Follow Up Meeting with NHTSA

February 7, 2013

EA11-003 TDI High Pressure Fuel Pump

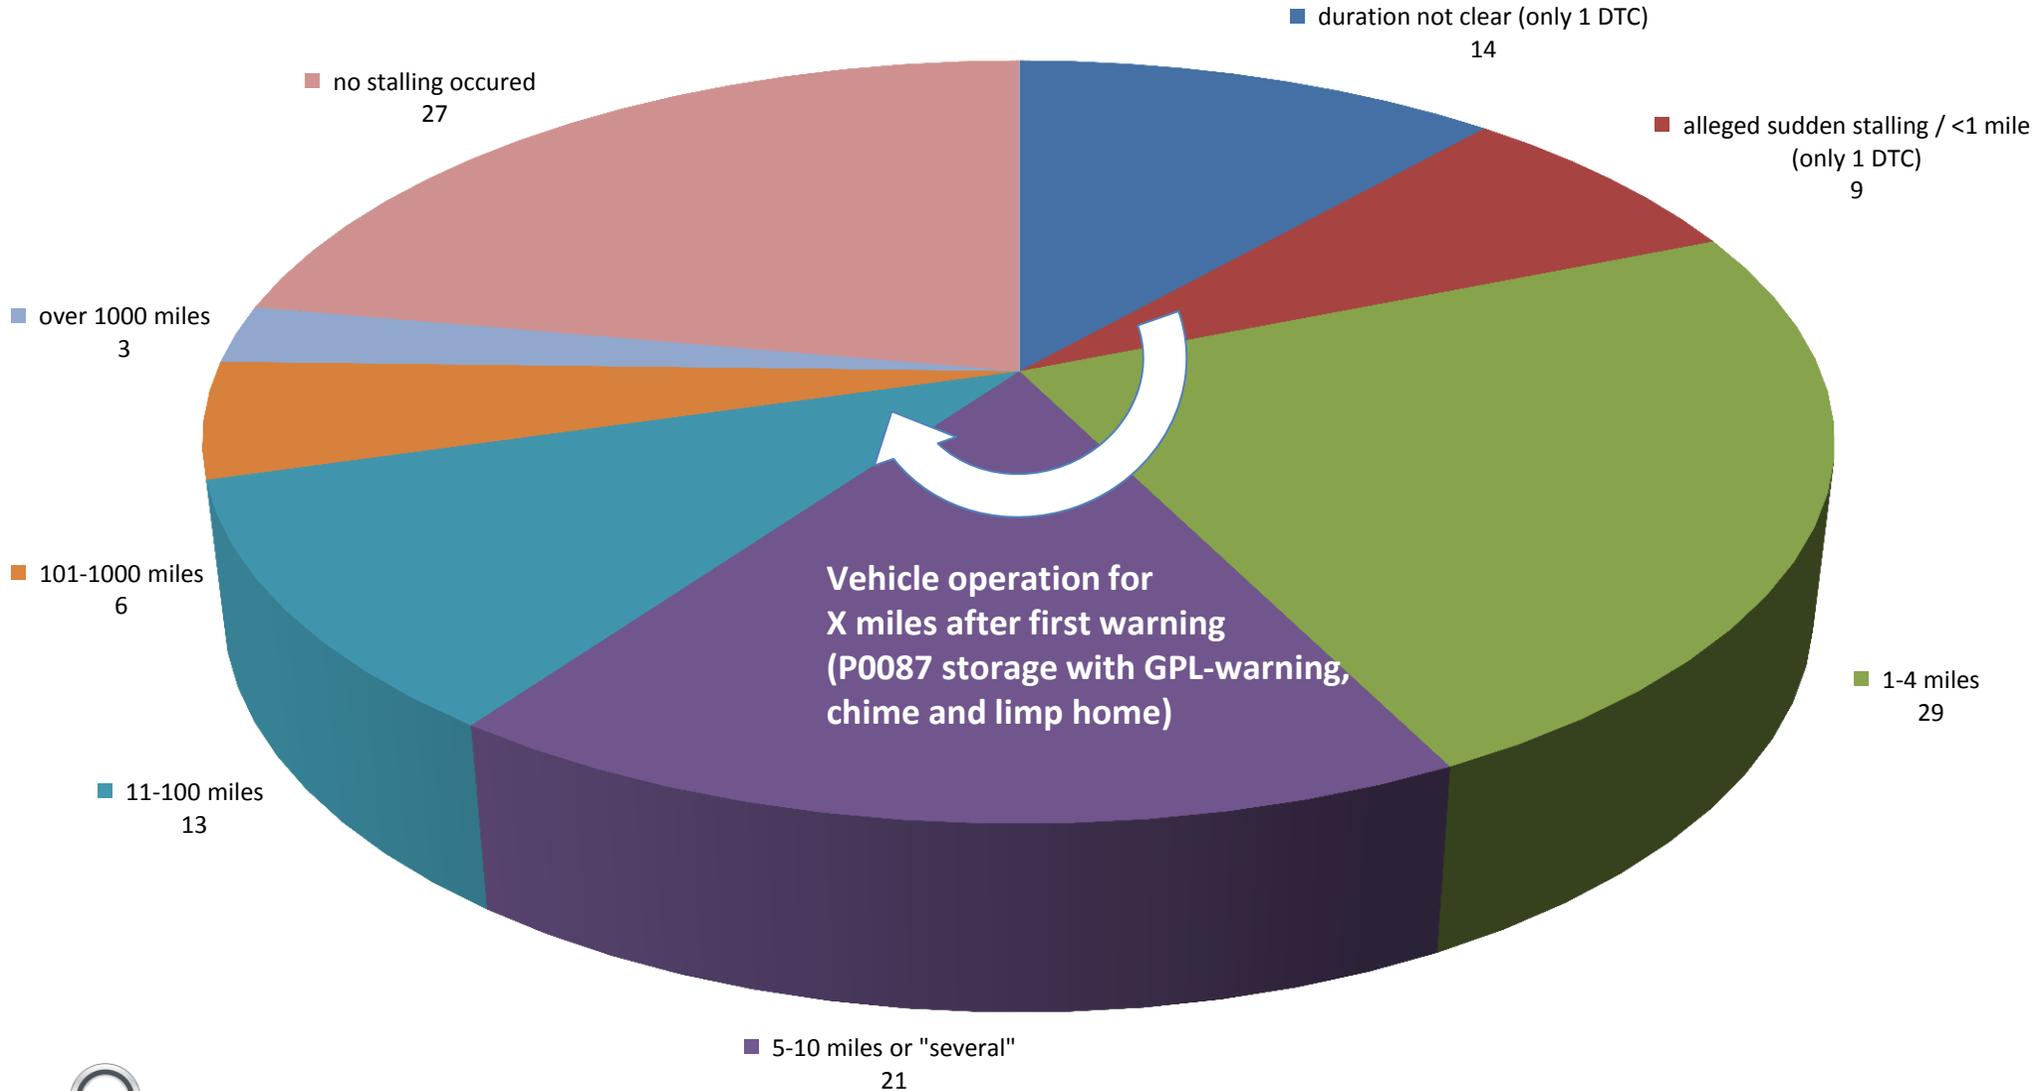
VOQ Review / Evaluation – Stall without warning?

VWAG test drives (misfuel – 3 minutes / drivetrain damage – 30/45 minutes) vs. Customer statements of sudden failure without warning

- For 122 of 212 VOQs a corresponding Diagnostic Log was detected.
- The DTC P0087 (rail pressure deviation) is stored, when fuel pressure in the rail does not follow the command value. This DTC considered as the essential DTC: P0087 activates the flashing glow plug warning and triggers the limp home mode, in the instance when it is stored.
- Multiple P0087 recordings are possible, as diagnosis is performed for each rail pressure control path (Metering unit, Pressure Reg Valve, Cylinder Pressure Control?)
- In all incidents, where data is available, DTCs (P0087 and additional) are set.
- DTCs do not provide information about rough running, sluggish and hesitating engine operating. There may be additional warning to the customer (as stated in some VOQs) that precede any recorded system reaction.
